ENVIRONMENTAL REVIEW TEAM REPORT

THISTLE ROCK PLANNED RESIDENTIAL DEVELOPMENT GUILFORD, CONNECTICUT

APRIL 1979

FIGURE 1.

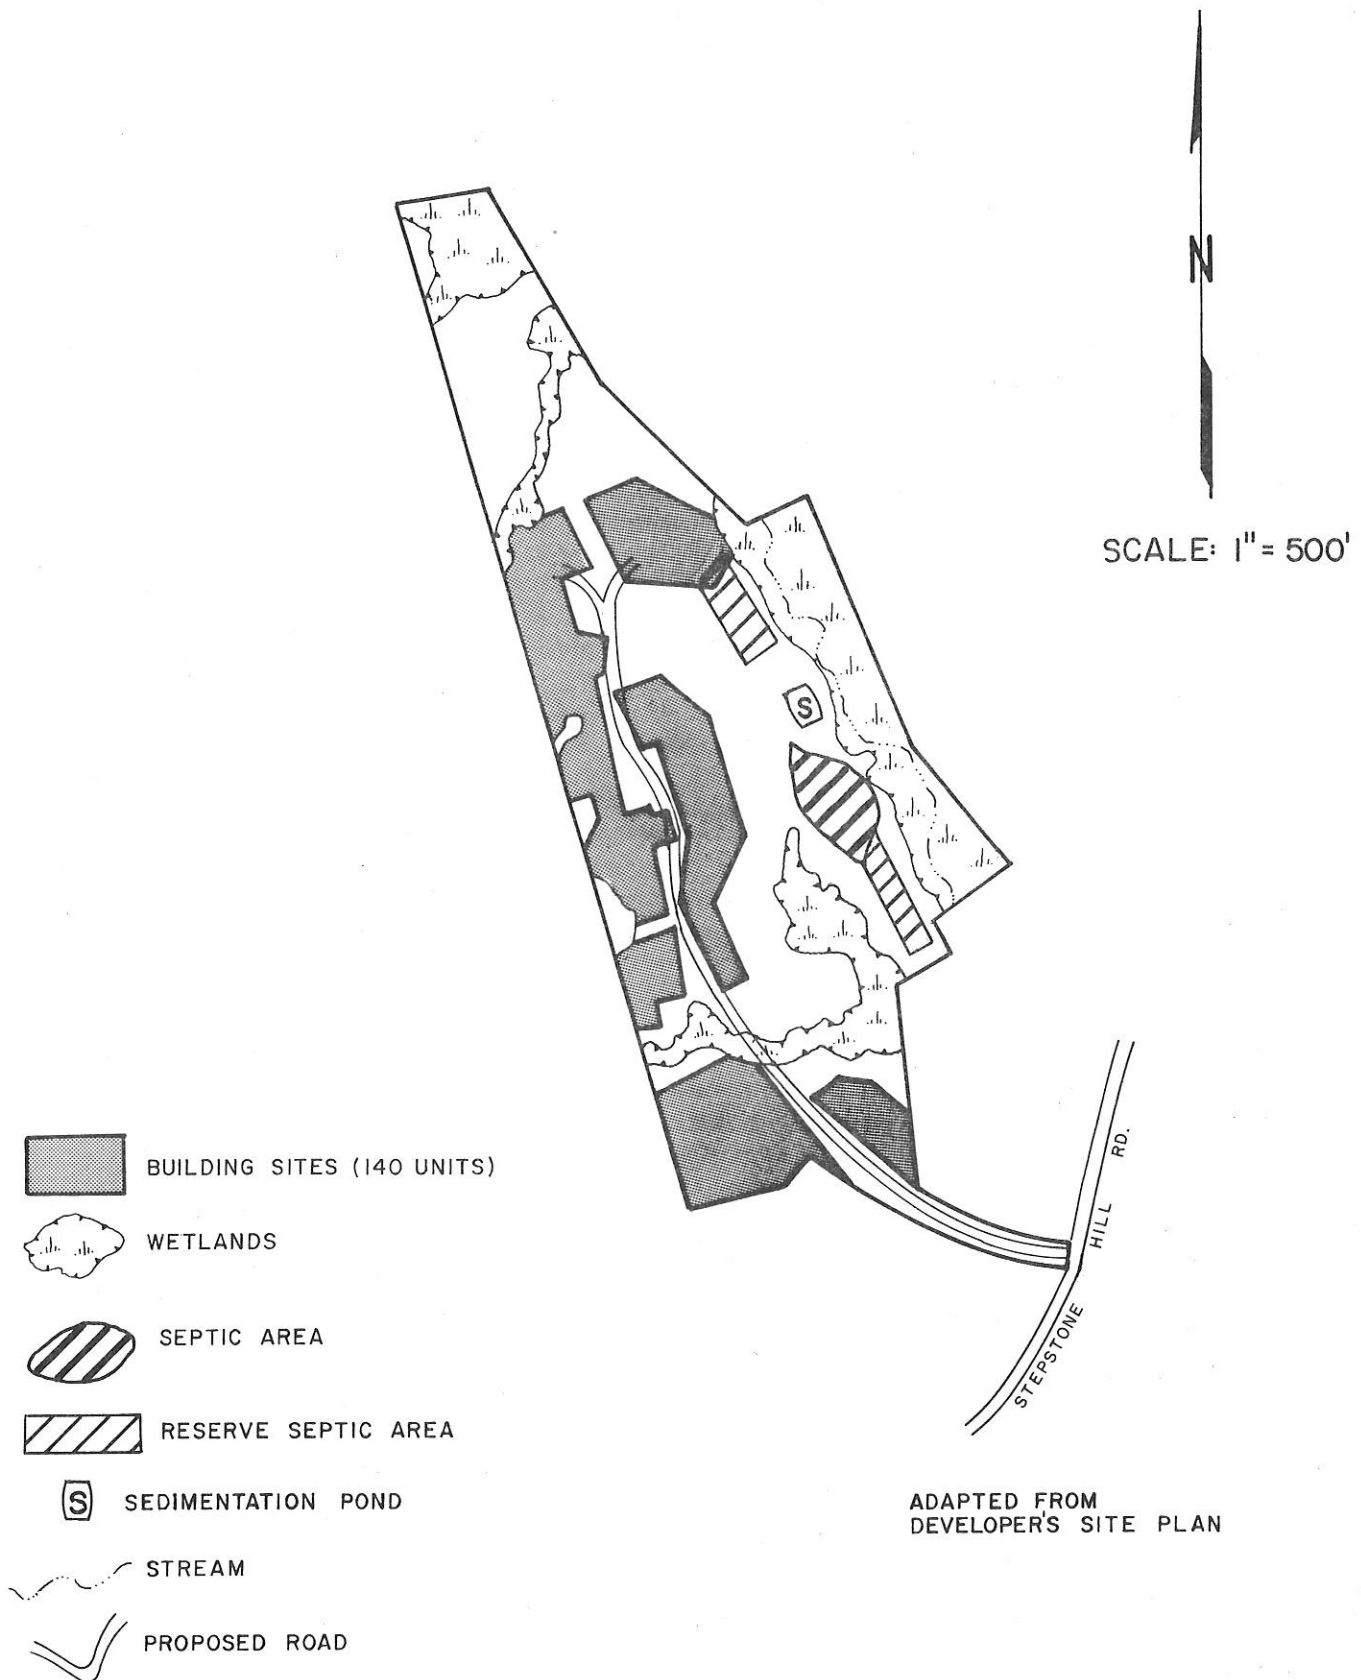
- . The proposed stream crossing at the southern portion of the site is one of the critical areas of the road system. The size of the culvert should be large enough to eliminate the road from overtopping and the outlet of the culvert should have a rock lined stilling basin to eliminate streambelt erosion at this point.

The proposed sedimentation pond (see Figure 1) is located in an area that has been mined of sand and gravel. Construction of this pond would require a Corps of Engineers 404 permit and specific details regarding pond design should be checked with permit requirements as established by the Corps.

The existing contour at the pond site is about the elevation of the wetland area abutting Little Meadow Brook. Any dam built to create a pond in this area should have the outside toe protected from eroding velocities of Little Meadow Brook. Little Meadow Brook appears to be about 25 feet away from the downstream toe of any embankment in this area. It is also recommended that the pipes discharging storm water into the proposed pond be provided with some type of energy dissipators to slow water velocities and dissipate energy.

The topography over which the road is to be built ranges up to 12 to 15 percent. There will be places of cuts and fills which will cause no real problems if concentrated surface water is kept off them. The stream crossing at the southern portion of the site is one of the critical areas of the road system. The size of the culvet should be large enough to eliminate the road from overtopping and washing the roadfill downstream. The outlet of the culvet should have a rock-lined stilling basin to eliminate streambed erosion at this point.

The road and a parking lot are planned accross a defined drainageway east of lot number 9 N/F William and Ann O'Grady. It is recommended that this drainageway be kept open or another satisfactory means of drainageway provided.

FIGURE 3.

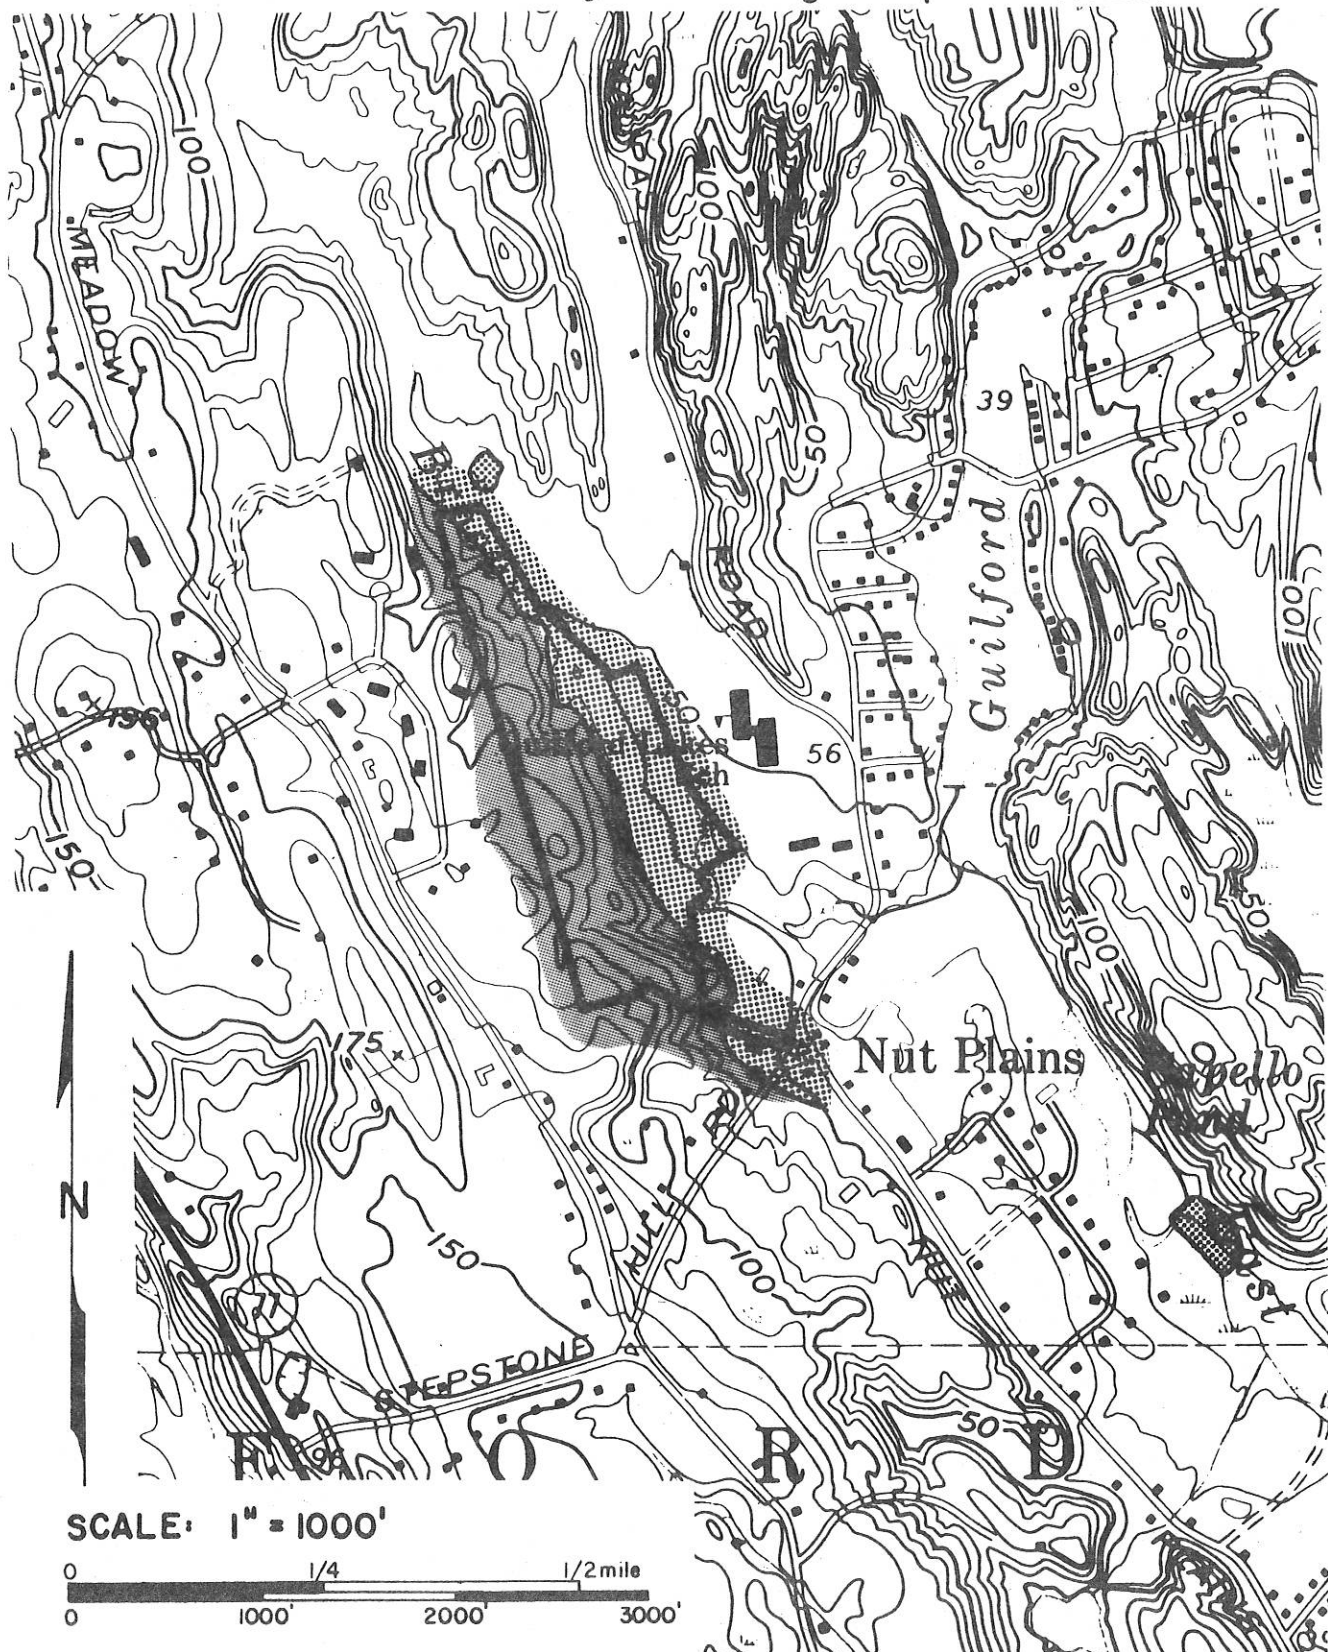
The Thistle Rock property may be separated into two distinctive topographic-surficial geologic units (see Figure 3). The western unit is a moderately to steeply sloping, somewhat knobby area in which a thin deposit of glacial till overlies bedrock. The bedrock is visible in several places in the form of small but prominent outcrops. Although it was not practical to include outcrop locations in Figure 3, the developer has prepared a large-scale site plan which indicates areas of exposed bedrock. The till deposit consists of round to angular rock fragments of widely varying sizes. Because of its stony, compact texture, groundwater movement through till is usually very slow and excavation with hand tools is difficult.

The eastern unit is a relatively flat area consisting of comparatively thick glacial sand and gravel deposits. Records from wells in the vicinity of the site indicate that the deposits are as much as 76 feet thick directly underneath Little Meadow Brook, thinning to 45 feet or less near the sides of the valley (the lines of contact with the till deposits).¹ In the area of the proposed leaching field (see Figure 1), the sand and gravel is estimated to be at least 20 feet thick.

FIGURE 4.

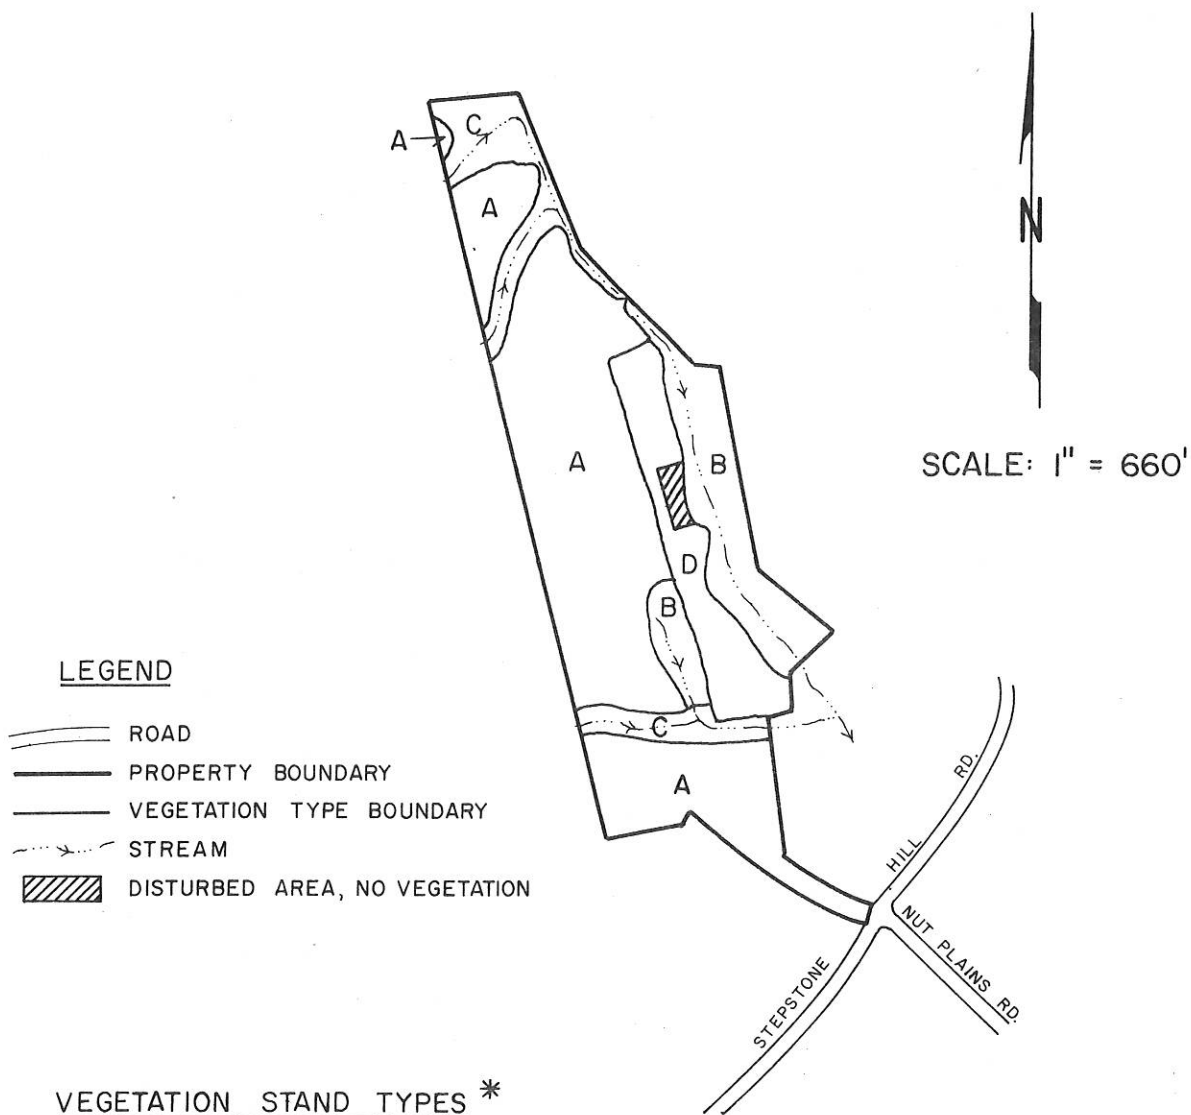
Several large healthy specimen trees are located in stand A. These trees would have aesthetic value if they could be incorporated into the landscape design of the area. Special care should be taken not to injure these trees or disturb the soil under their crowns during construction.

Windthrow of the shallow rooted trees such as red maple may be increased if openings are created in or near the hardwood swamp (stand C). Such openings would allow wind to flow through rather than over this stand. This new factor, together with the saturated soils and shallow rooted trees already present, would increase the potential for windthrow in this area. Non-developed buffer zones of at least 50 feet around these wetland areas would help reduce changes in windflow patterns, reducing increased windthrow hazards.

A fuelwood thinning in both stands A and C, removing approximately one-third of the trees, would result in a more stable forest that would be better able to withstand the environmental changes brought on by development of this property. Dead, unhealthy, damaged and undesirable trees should be removed leaving the healthier, higher quality trees in the residual stand. This thinning will reduce competition between trees for space, nutrients, water and sunlight. In stand C (hardwood swamp) this thinning will give the trees opportunity to become more wind firm through enlargement of root systems and crowns. In sections of stand A where development would be intense, an effort should be made to utilize the wood products being removed.

Several rows of a mixture of white pine, hemlock and larch could be planted 8' to 10' apart, along the eastern and perhaps western side of the old field (stand D). This planting would eventually provide a visual barrier, help to reduce noise levels in the area and provide wildlife with cover.
